Subject: Project No. 704 – BWRVIP Response to NRC Request for Additional Information
on BWRVIP-138, Revision 1

Non-Proprietary BWRVIP Response to NRC Request for Additional Information on “BWRVIP-138, Revision 1: BWR Vessel and Internals Project, Updated Jet Pump Beam Inspection and Flaw Evaluation Guidelines”

**BWRVIP Response to NRC Request for Additional Information on
“BWRVIP-138, Revision 1: BWR Vessel and Internal Project, Updated Jet Pump Beam
Inspection and Flaw Evaluation Guidelines”**

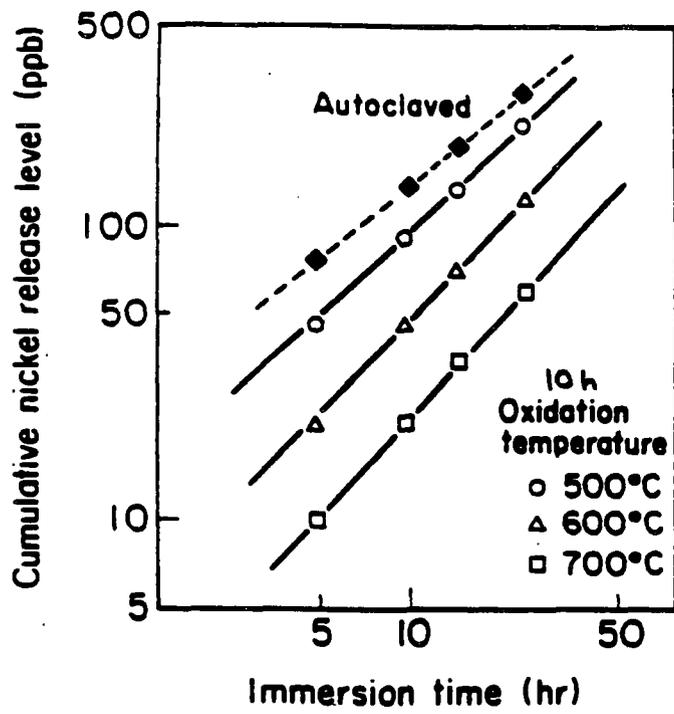
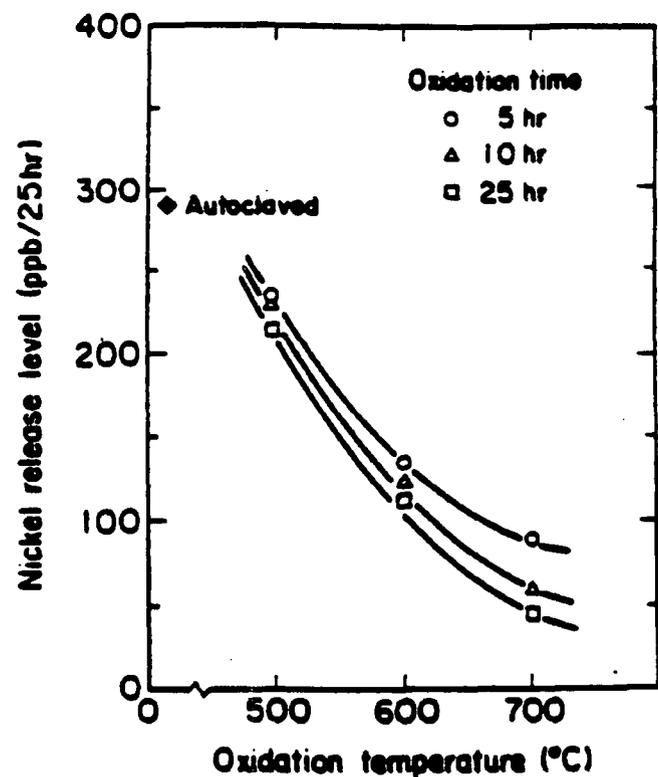
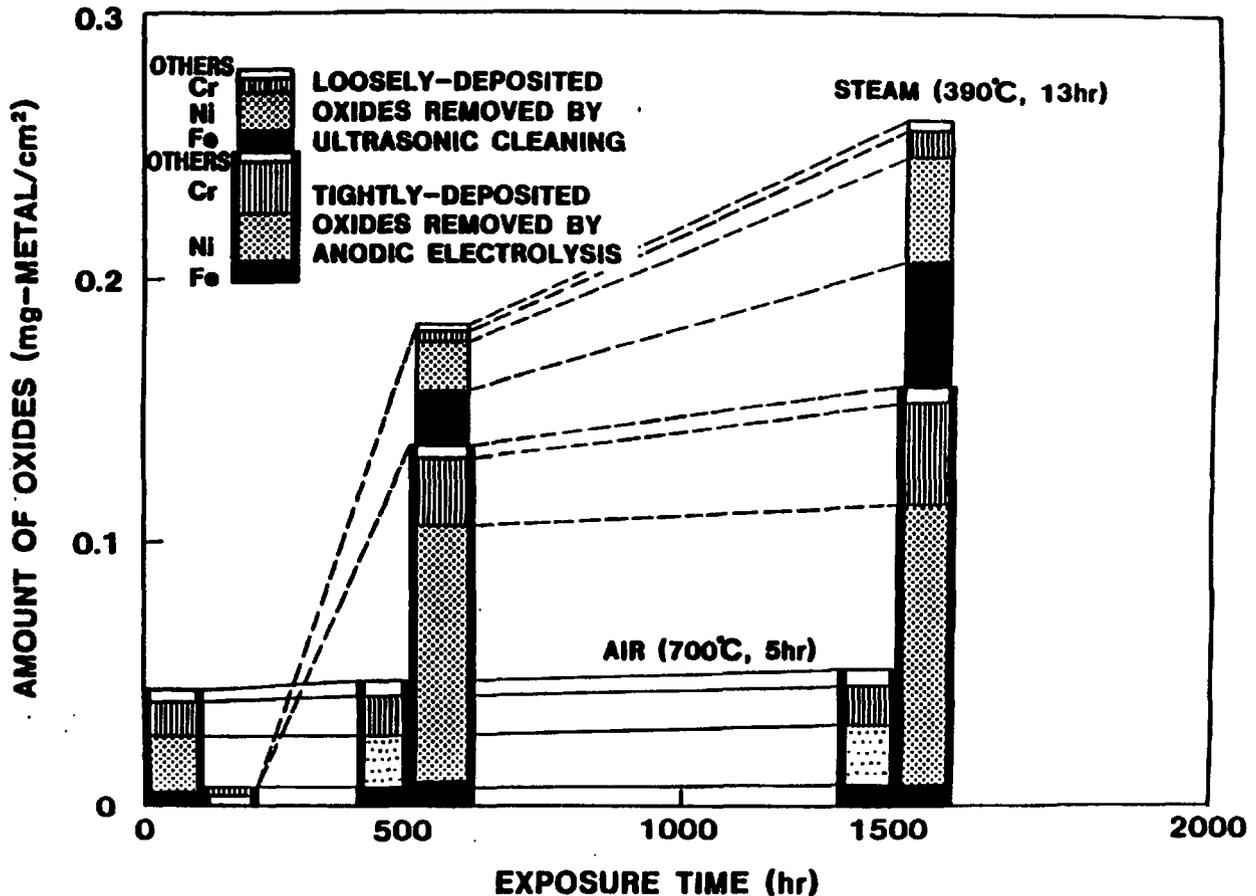
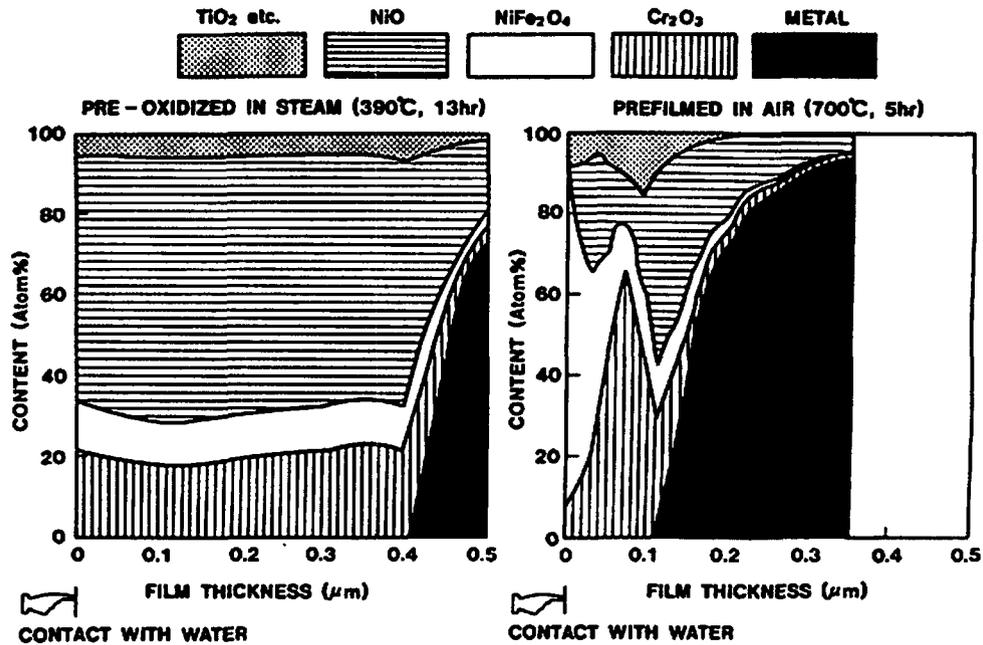
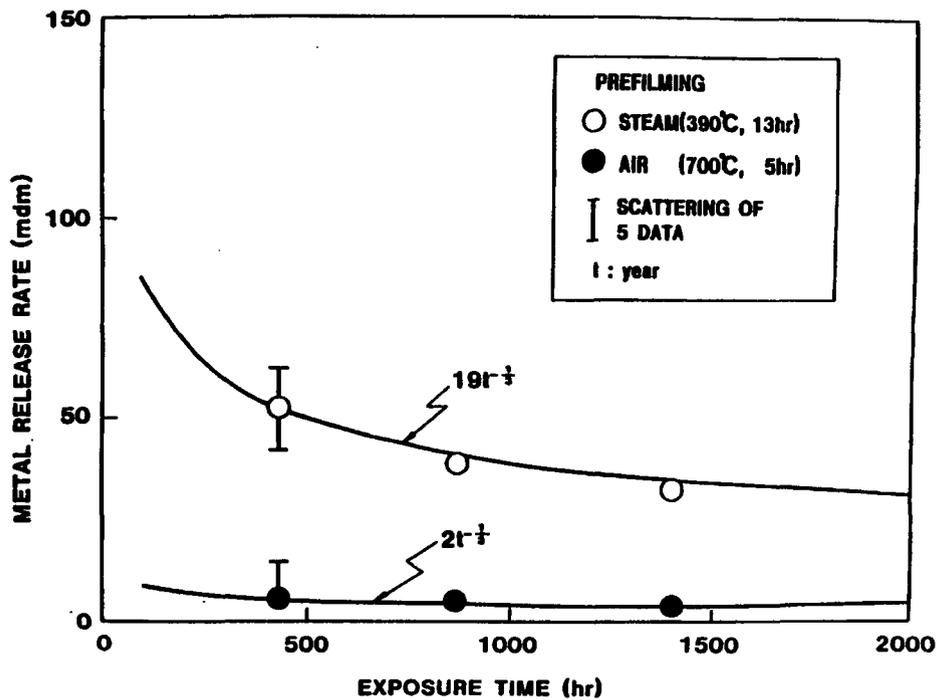
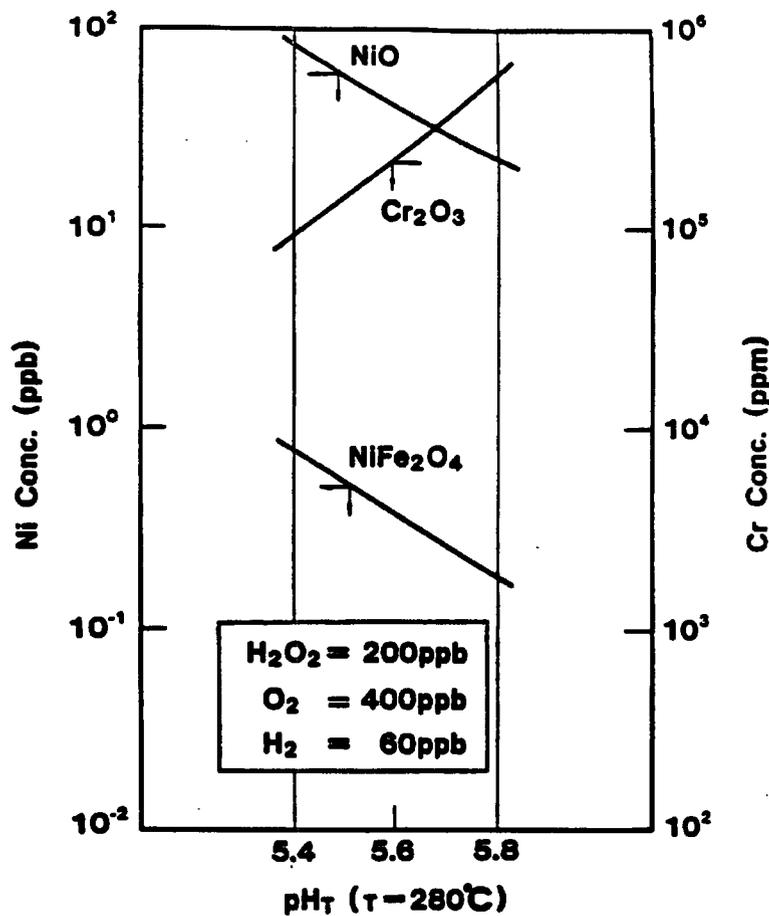
Has the BWRVIP considered the effect of surface condition on initiation of stress corrosion cracking? A paper from Foucault and Benhamou, “Influence of the Surface Condition on the Susceptibility of Alloy X-750 to Crack Initiation in PWR Primary Water” 1993, TMS 6th International Symposium of Environmental Degradation of Materials in Nuclear Power Systems-Water-Reactors is potentially relevant. This is not the boiling water reactor (BWR) environment, but it is possible that the surface condition is important in both BWR and pressurized water reactor (PWR) environment in terms of initiation.

The BWR testing experience shows similar surface effects results albeit these studies only examined the effect of surface condition on subsequent general corrosion performance in BWR environments rather than SCC response. However, the identical effect/benefit of optimum surface condition would also be anticipated relative to SCC resistance.

Numerous BWR environmental general corrosion studies [2-5] have been performed on Alloy X-750 corrosion films in recognition of the fact that Alloy X-750 components (e.g., fuel springs) have a high corrosion rate in the highly oxidizing (O_2/H_2O_2) BWR core environment [6]. The inhibition of ^{58}Co and ^{60}Co directly generated from the release of ^{58}Ni and ^{59}Co , respectively, from Alloy X-750 general corrosion would be an effective method to reduce radiation exposure.

As was the case for PWR environments, it was believed that pre-oxidation of Alloy X-750 is a method to mitigate its subsequent aqueous corrosion in the BWR environment and, thus, reduce radiation dose rates while still maintaining structural margin. The creation of a thinner, more adherent and more ductile film would also increase Alloy X-750's resistance to IGSCC.

K. Tada, et al. examined air oxidation as a candidate surface treatment for mitigation of Alloy X-750 general corrosion in BWR type environments [2]. Oxide layers on Alloy X-750 were characterized to determine their relationship with subsequent corrosion using solution heat treated (SHT) Alloy X-750 in a vacuum followed by either air oxidation at 500-700°C (932-1292°F) for a maximum of 25 hours or autoclaved at 390°C (734°F) for 13 hours after aging as a control.

The results of the study revealed that the oxides varied in thickness from 30 nm (as-autoclaved) to 270 nm (as-oxidized plus immersion) and there were no obvious differences in oxides on pre-oxidized Alloy X-750 before and after short term 280°C (536°F) immersion. However, the oxide layer consisted of a thin film plus oxide particles on the film. The film was the spinel $FeNiFeO_4$ plus Cr_2O_3 and NiO while the oxide particles were also $FeNiFeO_4$. Specimens pre-oxidized for 10 hours at 500-700°C (932-1292°F) had 30-90% lower nickel release levels than the non-pre-oxidized material, Figure 1, and the nickel release level decreased with increasing pre-oxidation temperature and pre-oxidation time, Figure 2.

Y. Hemmi, et al. discovered that the highly protective oxide produced by air oxidation of Alloy X-750 consists of two distinct tightly adherent layers as illustrated in Figure 3:

The less protective autoclave corrosion film also consists of loosely deposited assorted oxides of Cr, Ni and Fe plus tightly adherent, but more soluble ~60% NiO plus ~20% Cr₂O₃, ~10% FeNiFeO₄ and ~10% TiO₂, Figure 4.

The Alloy X-750 corrosion rate decreased with time with the thickening of the FeNiFeO_4 and Cr_2O_3 protective films after exposure to a simulated BWR environment, Figure 5. Due to its low solubility, Figure 6, the FeNiFeO_4 outer oxide layer restricts the dissolution of Alloy X-750 while the inner Cr_2O_3 layer restricts Ni/Co diffusion.

Figure 7. Stress versus Time to Failure for Alloy X-750 in 288°C (550°) Water in 8 ppm Dissolved Oxygen [8]

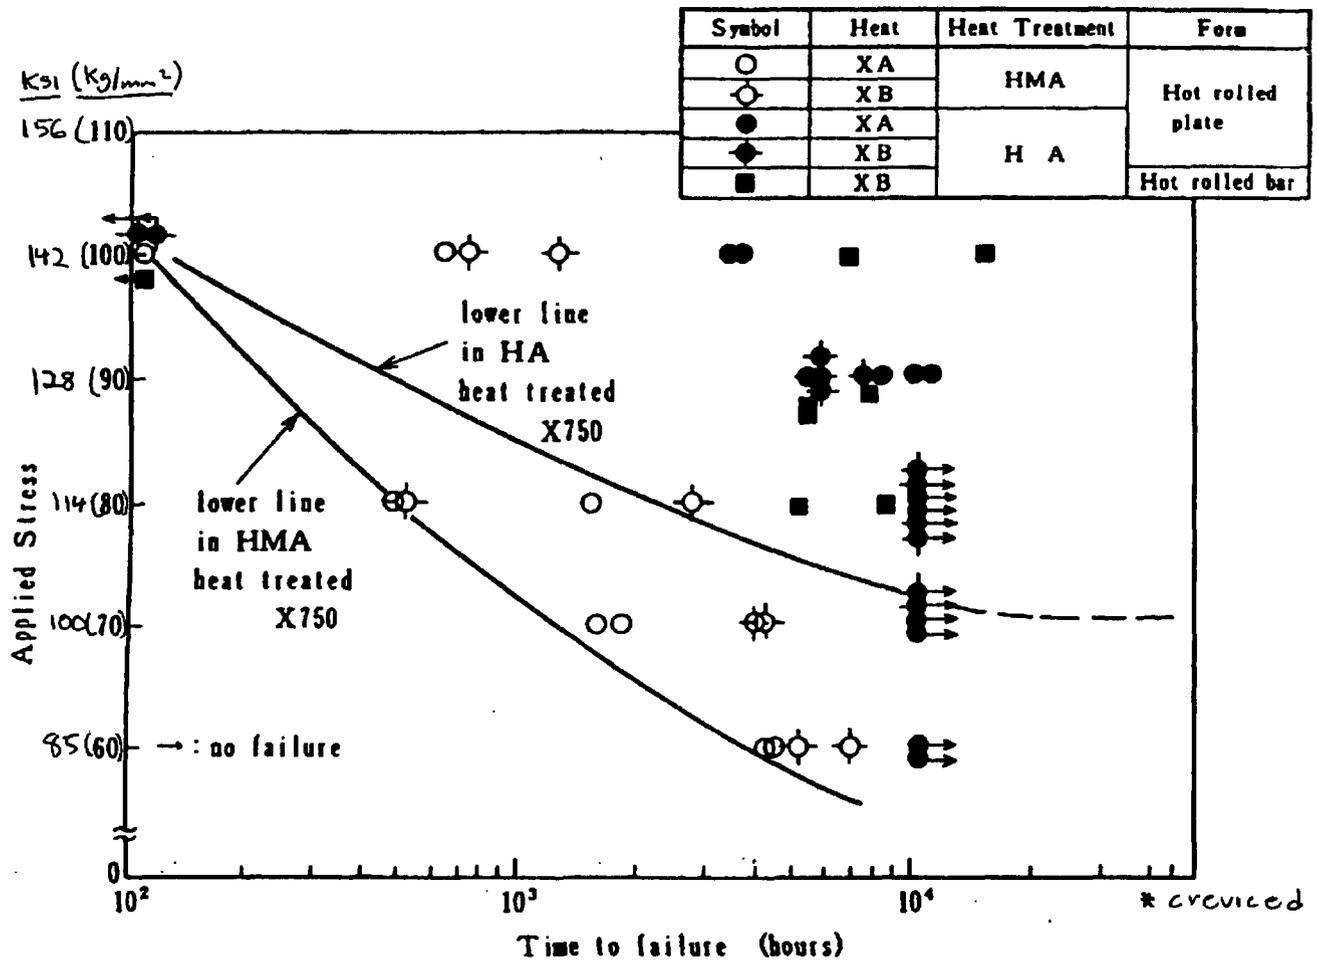
“Laboratory data for Alloy X-750 has shown a direct dependency of the time-to-initiation on the applied stress [2, 3].

Reference 2 includes design, procurement, fabrication and installation information for Alloy X-750, but no lab data while reference 3 is GE proprietary information. Provide the data discussed in the text or provide a reference document with this data.

As is the case for all alloys, the microstructure of Alloy X-750 has a dramatic effect on its IGSCC propensities. For example, numerous laboratory and in-reactor studies have been performed over the last few decades to especially determine the effect of microstructure, (e.g., cold work, grain boundary composition and various heat treatments/aging steps) on IGSCC propensities of Alloy X-750 with special emphasis on identifying the optimum heat treatment for IGSCC resistance in BWR-type environments [7-16].

Table 1 summarizes the interrelationship among heat treatment, microstructure and IGSCC propensities as evaluated by the creviced bent beam (CBB) test in high dissolved oxygen (8 ppm) water at 288°C (550°F) as an example of this microstructural-IGSCC correlation.

All these studies have indicated that a high temperature anneal (1066°C [1950°F]/1 hour) followed by direct aging (704°C [1300°F]/20 hours) provides the optimum IGSCC resistance, but not immunity to IGSCC in BWR (and PWR) environments. In fact, some in-reactor, but not irradiated, testing of Alloy X-750 in this heat treatment has demonstrated excellent results. For example, no IGSCC has been observed on creviced and un-creviced Alloy X-750 constant load specimens after sixteen (16) years of in-reactor exposure at stress levels exceeding 120% of the 288°C (550°F) yield stress [15-16].

As shown in Table 1, the more susceptible AH (HMA in Figure 7) heat treated Alloy X-750 had γ' Ni₃(Al,Ti) and η phase Ni₃Ti in the grain boundaries. The needle-like η phase was accompanied by a precipitate free zone (PFZ) along the grain boundaries, no precipitated

chromium carbides and fine γ' particles precipitated in the PFZ. The more IGSCC resistant HTH (HA in Figure 7) heat treated Alloy X-750 had only chromium carbide $Cr_{23}C_6$. This suggests that the presence of η phase, PFZ and fine γ' particles in the PFZ have some detrimental effect on IGSCC resistance.

Figure 10. Crack Length vs. Time for Alloy X-750 AH Tested in 288°C Water [17, 18]

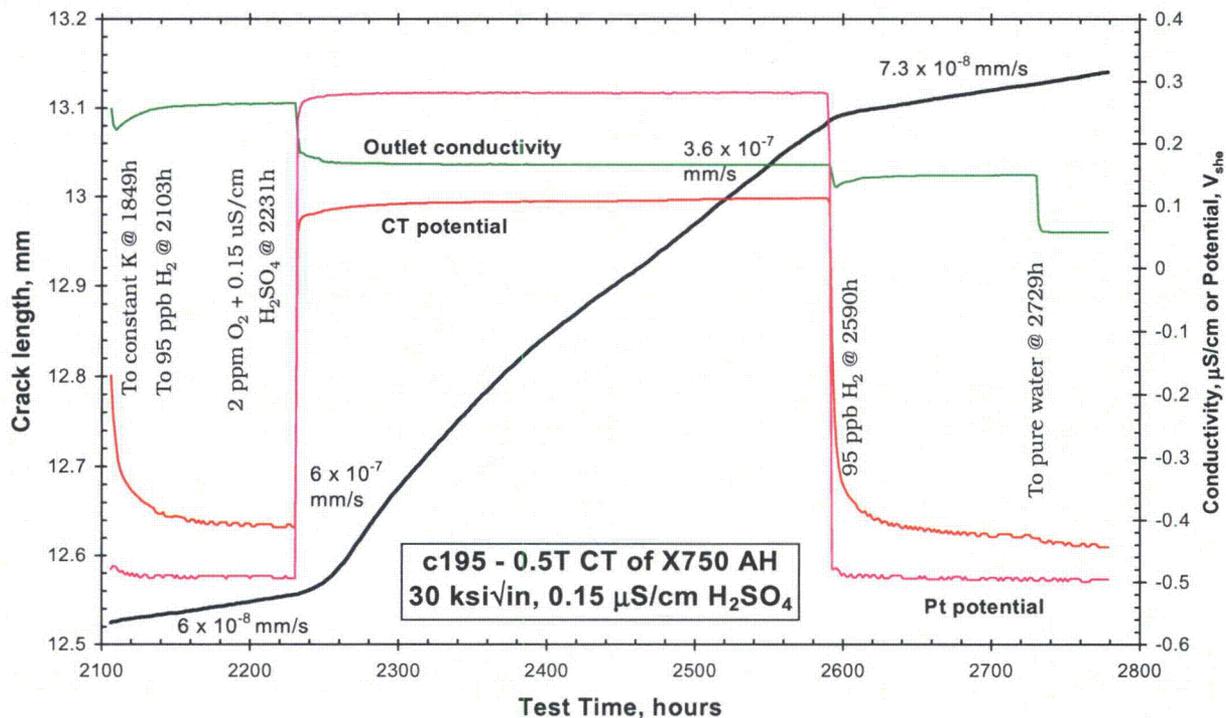
Elaborate on why data for Alloy 600 and austenitic stainless steels may or may not be applicable to Alloy X-750. What inputs were used to make these theoretical predictions and why is this trend important in this case given the fact that hold-down beams with EQA and high temperature heat treatments have nearly identical YS and are strengthened by precipitation instead of cold working as is the case for Alloy 600 and austenitic stainless steels? Does the theory support the

extrapolation of crack growth rate data to applied stress-intensity factor (K) values an order of magnitude lower than the applied K values for the measured crack growth rates?

As presented in Figure 10, which is reproduced from Figure 5.2² from BWRVIP-138, Revision 1 [17] and is also available in the open literature [18], HWC reduces the crack growth rates of Alloy X-750 in a similar manner it reduced the crack growth rates of cold worked Types 304, 304L and 316L stainless steel and Alloy 600. More specifically for Alloy X-750 AH, the factor of improvement (FOI) in crack growth rate reduction with the application of HWC is between approximately 5 and 10 as shown in Figure 10. It should be noted that the factor of improvement in crack growth rate proposed for Alloy X-750 in the HWC environment in BWRVIP-138, Revision 1 is only a factor of 2 which is very conservative as compared to the results presented in Figure 10.

Figure 5-2. Recent Data from GE GRC on Alloy X-750 [10]

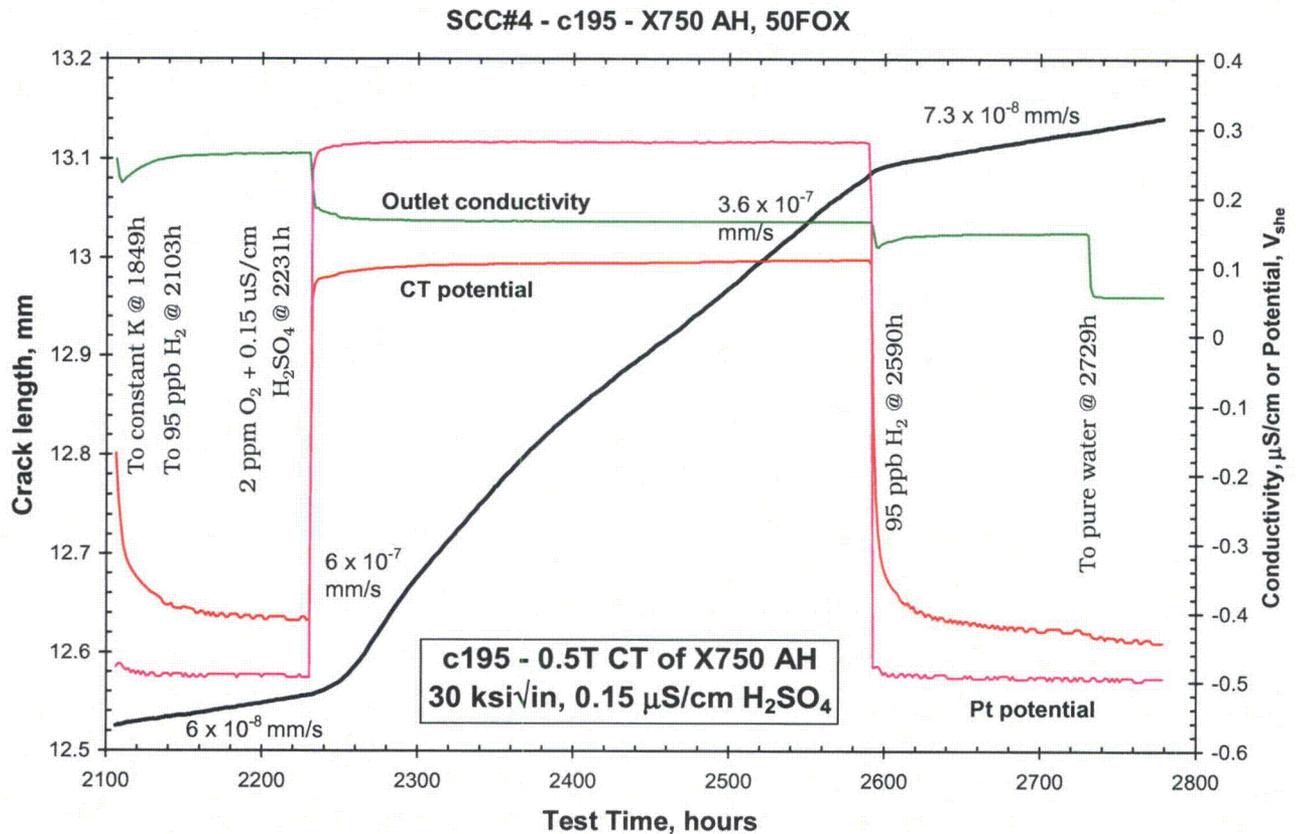
An error was noted that Figure 5-2 was a duplicate of Figure 5-4 in "BWRVIP-138, Revision 1. The correct Figure 5-2 is shown below. This figure will be incorporated in a revision to BWRVIP-138.
